BEFORE THE MERIDIAN CITY COUNCIL

IN THE MATTER OF THE)	
REQUEST FOR FINAL PLAT	
CONSISTING OF 108 BUILDING)	CASE NO. FP-2021-0053
LOTS AND 27 COMMON LOTS ON)	
27.42 ACRES OF LAND IN THE R-8	ORDER OF CONDITIONAL
ZONING DISTRICT FOR)	APPROVAL OF FINAL PLAT
PRESCOTT RIDGE SUBDIVISION)	
NO. 1	
)	
BY: KM ENGINEERING, LLP)	
APPLICANT)	
)	
)

STAFF REPORT

SUBJECT: FP-2021-0053

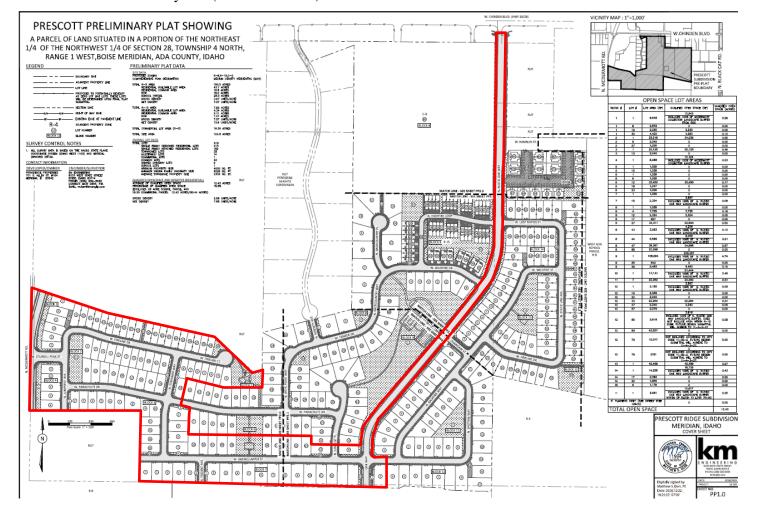
This phase combines phases 1 and 4 as shown on the phasing plan and excludes the hospital/medical center lot (i.e. Lot 80, Block 8). The hospital/medical center lot should be included in the subject final plat for consistency with the approved phasing plan as required by the Development Agreement; or, an amendment to the Development Agreement for that property should be requested and approved to remove that lot from the phasing plan prior to signature on the final plat for the subject final plat.

B. Final Plat (date: 9/24/2021)

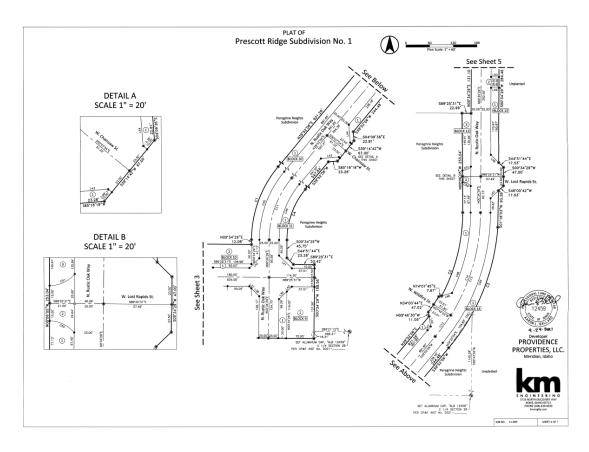
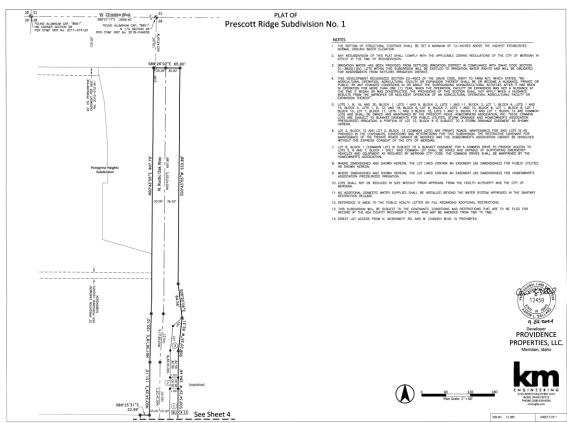
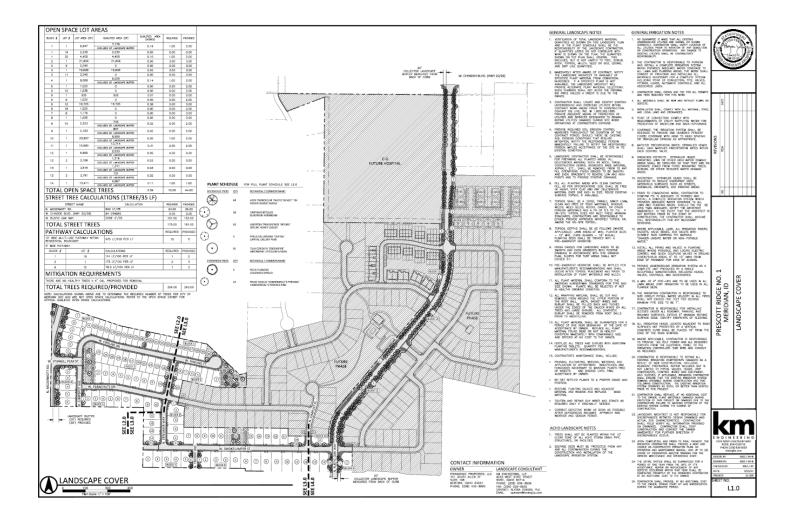
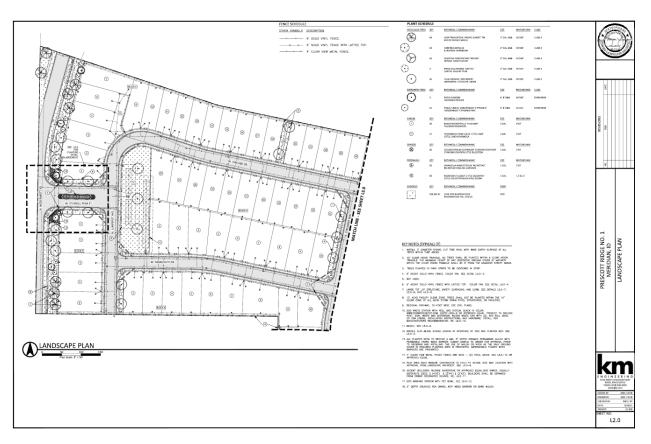
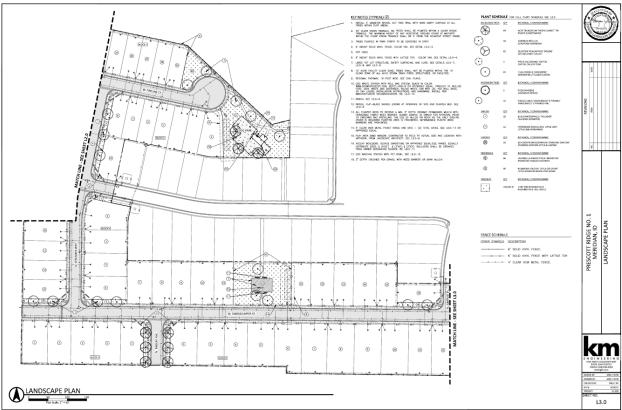
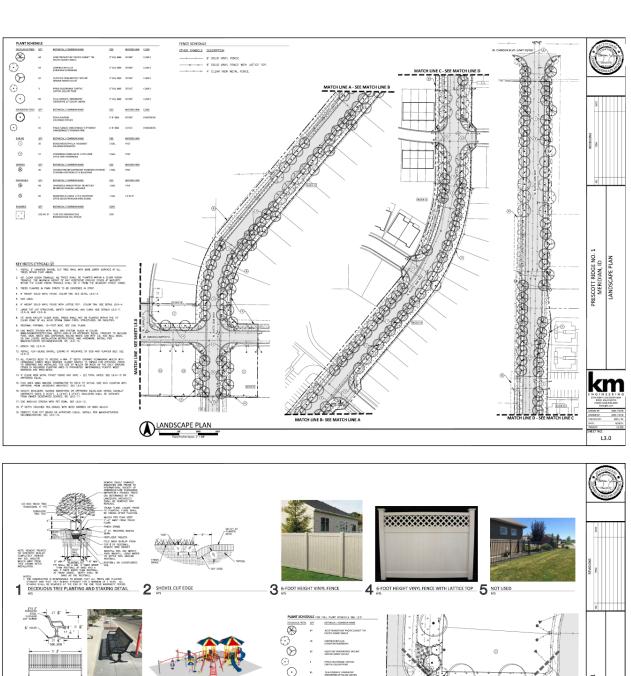
- 3. Prior to submittal for the City Engineer's signature, have the Certificate of Owners and the accompanying acknowledgement signed and notarized.
- 4. The final plat shown in Section V.B prepared by KM Engineering, stamped on 9/24/2021 by Aaron L. Ballard, shall be revised as follows:

- a. Include Lot 80, Block 8 (i.e. hospital/medical center lot as shown on the preliminary plat) in the boundary of the final plat in accord with the phasing plan as required by the Development Agreement; or, amend the Development Agreement for the hospital portion of the development to exclude that parcel from the phasing plan, prior to signature on subject final plat by the City Engineer.

- b. Include the recorded instrument number of the point of commencement graphically depicted on Sheets 1 and 2.
 - c. Depict the correct parcel configuration of the property at the southwest corner of SH-20/26 and N. Rustic Oak Way as shown on ROS #13153, property boundary adjustment for Providence Properties, LLC, Raymond Roark and Lonnie Kuenzli.

- d. Note #14: "Direct lot access from N. McDermott Rd., N. Rustic Oak Way and W. Chinden Blvd. is prohibited, unless otherwise approved."

An electronic copy of the revised plat shall be submitted prior to signature on the final plat by the City Engineer.

C. Landscape Plan (date: 9/23/2021), Fencing Plan & Amenity Details

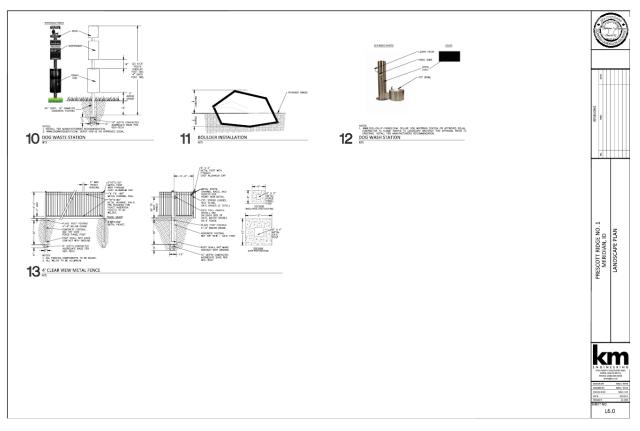
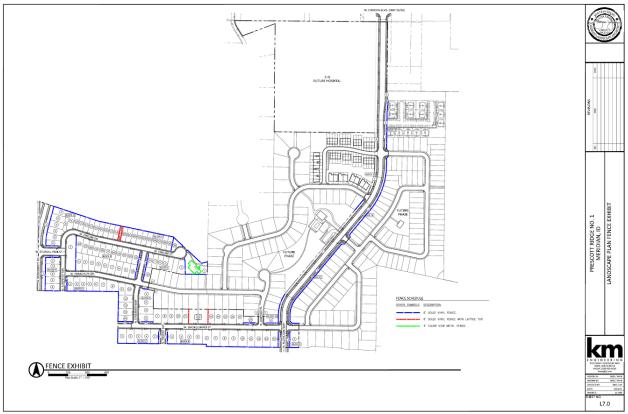
- 5. The landscape plan shown in Section V.C, dated 9/23/21, shall be revised as follows:
 - a. Depict shrubs (along with the proposed trees) within the street buffers along W. Chinden Blvd., N. McDermott Rd. and N. Rustic Oak Way as set forth in UDC 11-3B-7C.3a.

- b. Landscaping shall be depicted along *all* pathways in accord with the standards listed in UDC <u>11-3B-12C</u>; include a *mix* of trees and <u>shrubs</u> along with lawn and/or other vegetative groundcover.

- c. Depict noise abatement for the future SH-16 extension in the form of a berm or a berm and wall combination parallel to N. McDermott Rd. constructed in accord with the standards listed in UDC 11-3H-4D. A cross-section of the berm or berm/wall combination should also be included.

- d. If fencing is proposed along the west side of Lot 9, Block 1, depict a minimum 5' wide landscape buffer along the east side of Lot 8, Block 1 planted with shrubs, lawn or other vegetative groundcover as set forth in UDC <u>11-6C-3D.5</u>. Depict fencing on the plan if proposed.

An electronic copy of the revised landscape plan shall be submitted prior to signature on the final plat by the City Engineer.
